APPLICATION FOR RESOURCE CONSENT

**YOUR REFERENCE 24.3.04.47: SUBDIVISION –
J & N COWPER, 560 STANLEY ROAD, WHAKATANE**

YOUR REFERENCE 24.3.04.47: SUBDIVISION – COWPER
560 STANLEY ROAD, WAINUI

**BUILDING SITE FEASIBILITY REPORT
FOR
LOT 1 OF PROPOSED SUBDIVISION OF LOT 2 DP 310143
560 STANLEY ROAD
WHAKATANE**

SITE NOTES PLAN
1:250

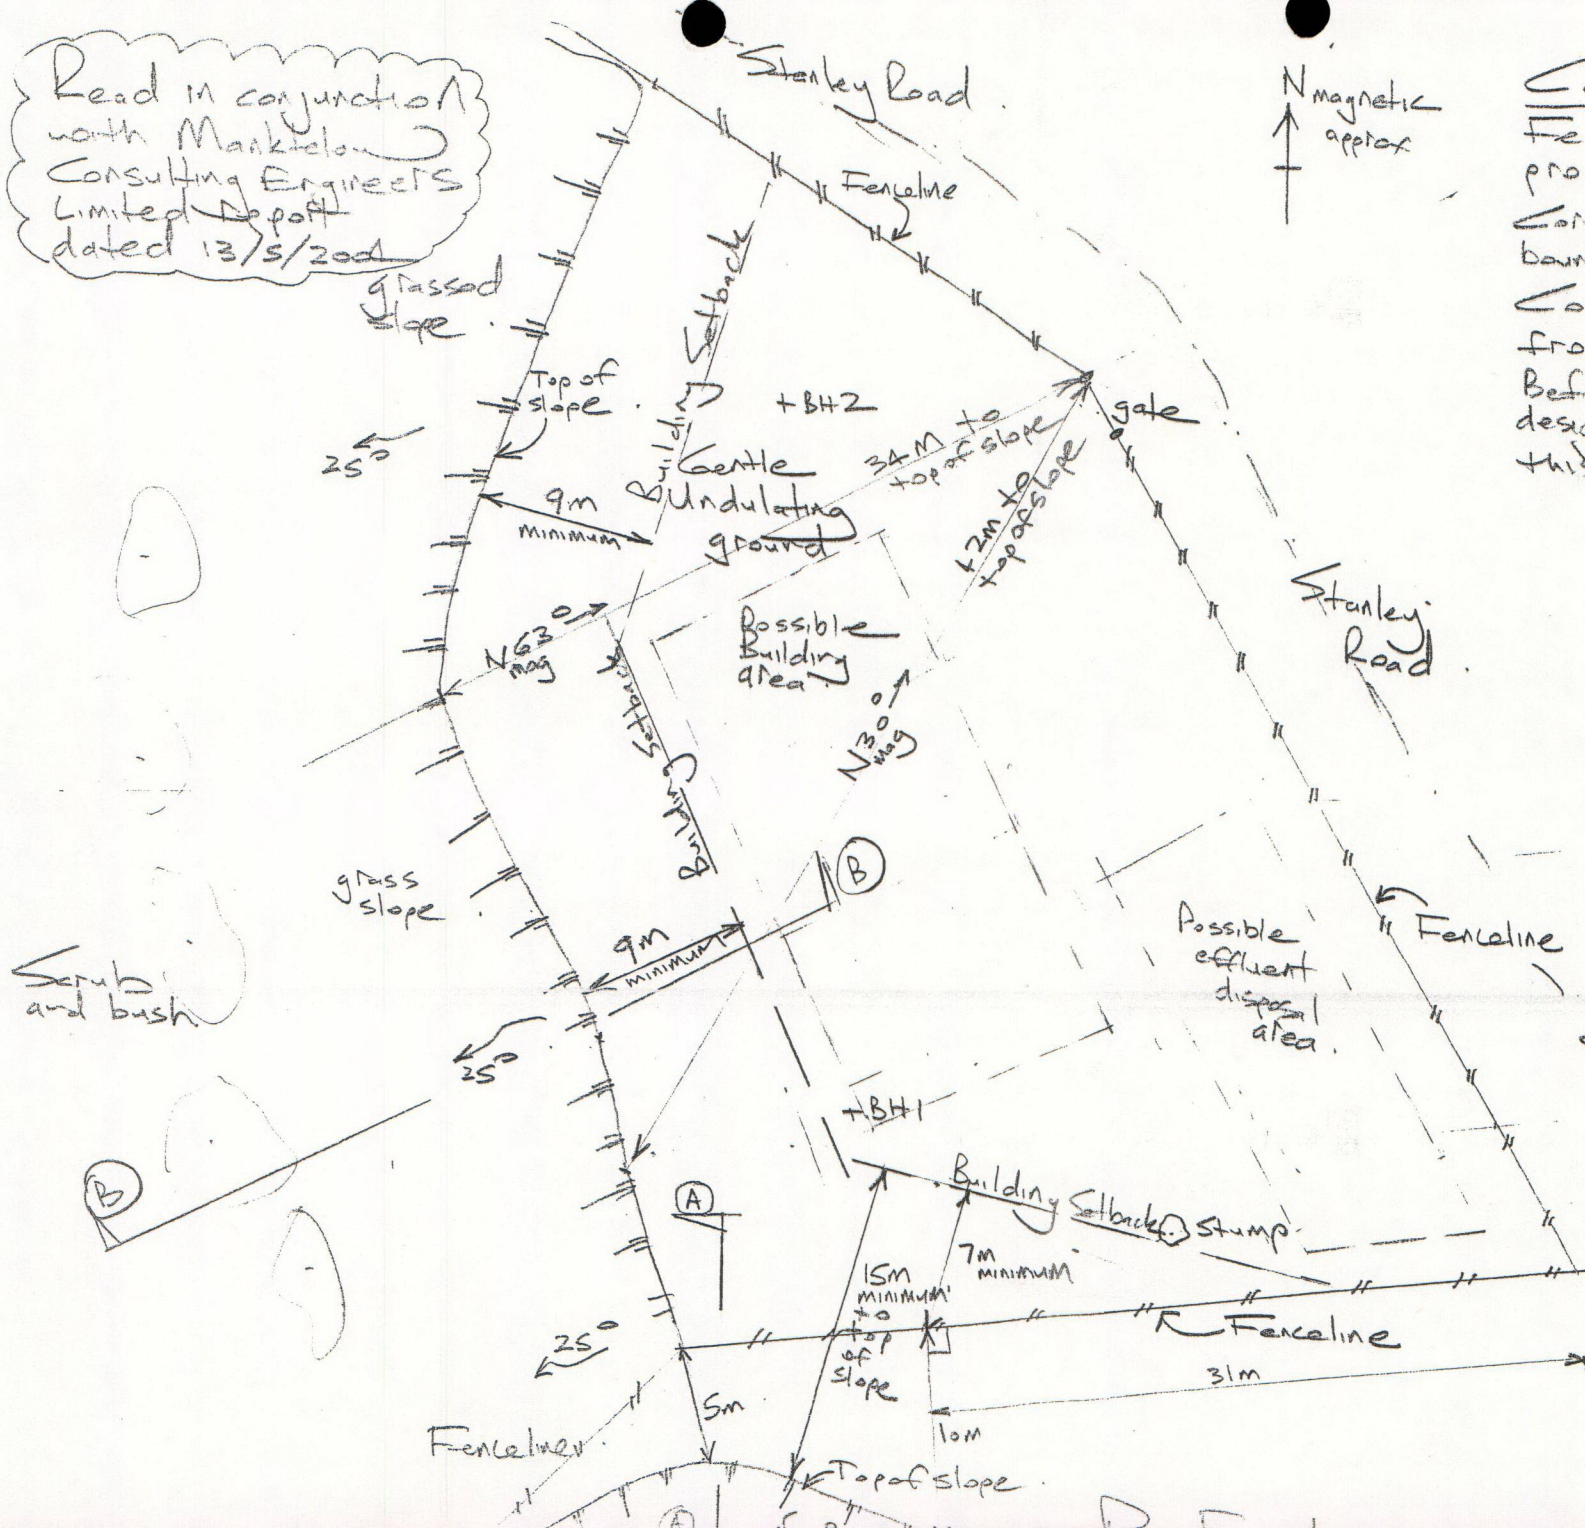
As a general rule of thumb for weathered and pumice ash deposits a building set-back margin based on a 2:1 (horizontal to vertical) 26° plane applied to the slope profile has been established as a practical and prudent tool for preliminary assessment of hillside slopes. Applying this approach to the existing contours suggests that a building line set at 9m from the top edge is appropriate for the western slopes.

A similar process was undertaken for the southern slope profile beyond the boundary fence with a 15m setback resulting.

The attached Site Notes Plan showing the potential building area with the above mentioned setback distances and the slope profiles refer.

- 8.1 As with any elevated hillside property there is a risk of slope instability. Our investigations suggest that it is prudent to observe minimum setback distances from the top edges of the slopes at this site. Observations suggest there is a low risk that instability will extend back into the building area at these setback distances. Specialist geotechnical review and investigation will be required before consideration can be given to locate any buildings closer to the tops of the slopes than specified on the attached site notes plan.
